Access Compliance Report Public Rights-of-Way (Curb Ramps)

Main Street: SHAKESPEARE_DR Cross Street: HARRISBURG_RD Location: N

ADA ID: RPAT211202092432 Ramp Type: Type 1 - Perpendicular Diagonal Initial Pass/Fail: Pass Overall Compliance: No Severity Score: 0

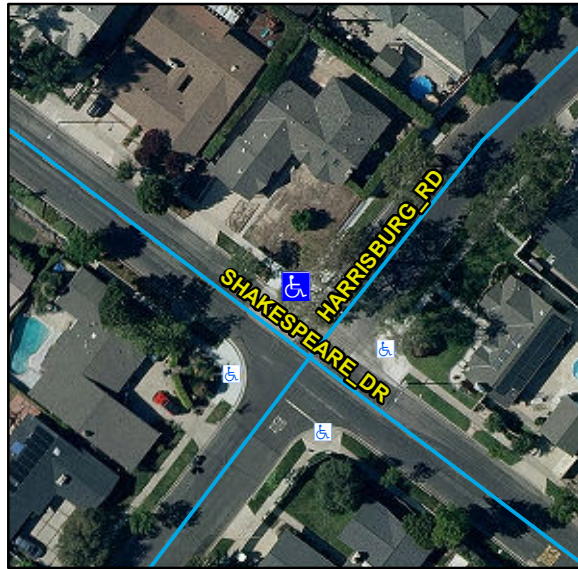
Compliance	Description	Data	Compliance	Description	Data
N/A	Ramp Length (in)	91	N/A	Flare Type LT	
Yes	Ramp Width (in)	48			Sloped
Yes	Ramp Run Slope (%)	7.8	N/A	Flare Slope LT (%)	7.2
Yes	Ramp Cross Slope (%)	0.8	N/A	Flare Traversable LT	No
N/A	Landing Present	Yes	N/A	Flare Type RT	
N/A	Landing Length (in)	49			Sloped
Yes	Landing Width (in)	51	N/A	Flare Slope RT (%)	6.1
No	Landing Run Slope (%)	2.2	N/A	Flare Traversable RT	No
No	Landing Cross Slope (%)	2.1	Yes	DWS Provided	Yes
N/A	Landing Movement Obstructed?	No	Yes	DWS Contrast	Yes
	Landing Movement Type	N/A	Yes	DWS Length (in)	36
N/A	Landing Shared	No	Yes	DWS Full Width	Yes
N/A	Clear Space	Yes	Yes	DWS Offset Left (in)	0
N/A	Clear Space To Crosswalk (in)	48	Yes	DWS Offset Right (in)	N/A
N/A	Marked Crosswalk 1	No	N/A	Marked Crosswalk 2	No
	Crossing 1 Direction	SW		Crossing 2 Direction	SE
	Marked Crosswalk 1 Width (in)	N/A		Marked Crosswalk 2 Width (in)	N/A

N/A	Ramp Inside Crosswalk 1	N/A	Yes	Ramp Inside Crosswalk 2	N/A
	Crossing 1 Slope (%)	4.1		Crossing 2 Slope (%)	1.6
	Crossing 1 Cross Slope (%)	1.2		Crossing 2 Cross Slope (%)	1.8
Yes	Gutter Ponding	No	Yes	Curb Slope	2
Yes	Gutter Lip Height (in)	0		Road Run Slope (%)	0.2
Yes	Gutter Run Slope (%)	1.5		Road Cross Slope (%)	4
Yes	Gutter Cross Slope (%)	1.6			
Yes	Overall Surface Condition: Acceptable		Yes	Perp Joint Present	Yes
	Cross Gutter Present?	Yes		Spandrel Present?	Yes
	Replace Cross Gutter?	No		Replace Spandrel?	No

Possible Solutions:

Remove & Replace Landing.

R304.2.2-Perp, R304.3.2-Para, R304.5.3, STD 1115
